| BT27.35-P-0002-01A | Installation of a pressure feed valve | | |

**Production breakpoint data/Modifications/New features**

P27.35-0212-09

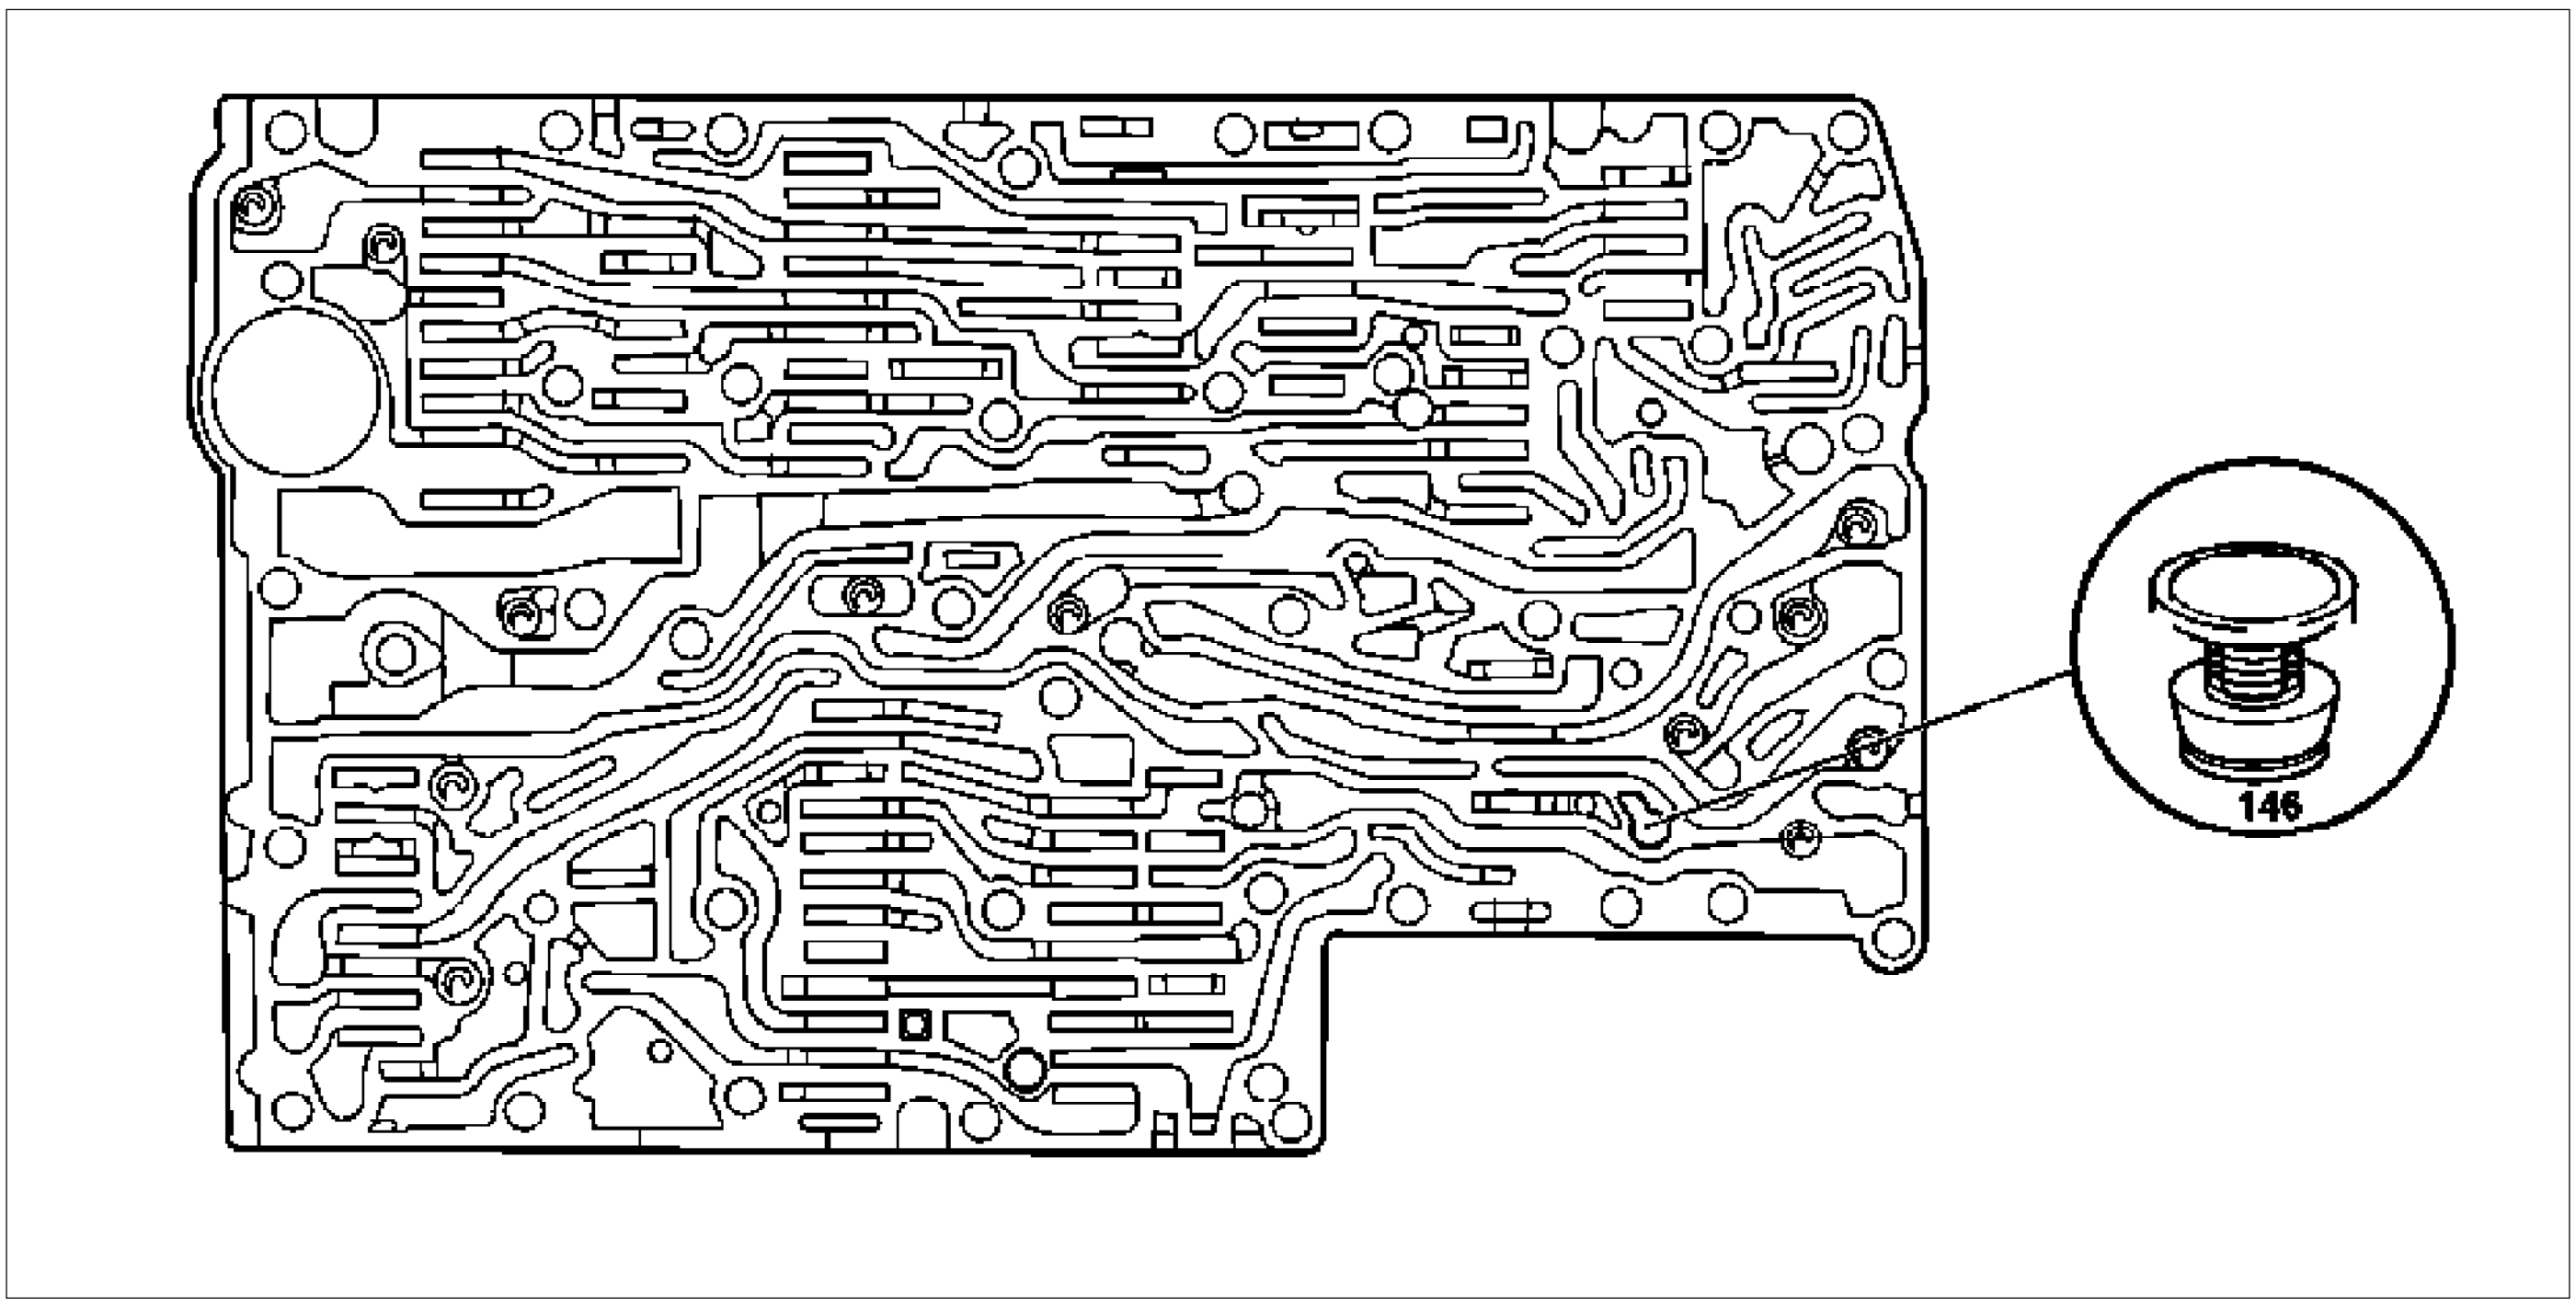
A pressure feed valve (146) has been installed in the 2-3 shift group to prevent harsh 3-2 downshifts and roll-out shifts.
